**ADDENDUM NO. 3**

Ward Road Project  
Project #22-360-201

Addendum 1

WARD ROAD WATERLINE RELOCATION

CONNECTION DETAILS

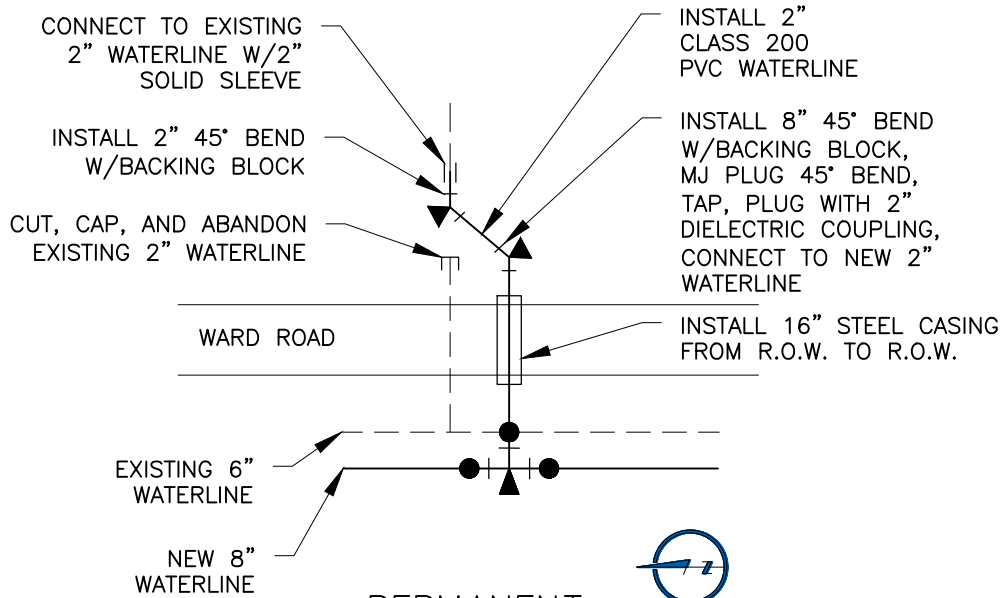
1. The following Service Reconnections shall be Long Service Reconnections:
  - a. Sheet 9 – Approximate Station 35+30
  - b. Sheet 9 – Approximate Station 38+40
  - c. Sheet 13 – Approximate Station 57+40
  - d. Sheet 14 – Approximate Station 60+18
  - e. Sheet 16 – Approximate Station 67+42The following is a new Long Service Reconnection:
  - a. Sheet 15 – Approximate Station 65+00 (New)
2. Clarification:
  - a. The Note *MJ Plug Valve* at Stations 57+00 and 58+75 are locations to install 8"x8"x8" tees with an 8" gate valve and box on the branch. The gave valve shall be MJ plugged.
3. Clarification:
  - a. Connection F20 shall connect to existing waterline with an 8" solid sleeve.
4. Connection E20 shall be replaced with the enclosed connection detail and include a crossing of Ward Road as seen in detail.

**TEMPORARY**  
**CONNECTION DETAIL**  
 Restrain Throughout

**PERMANENT**  
**CONNECTION DETAIL**  
 Restrain Throughout
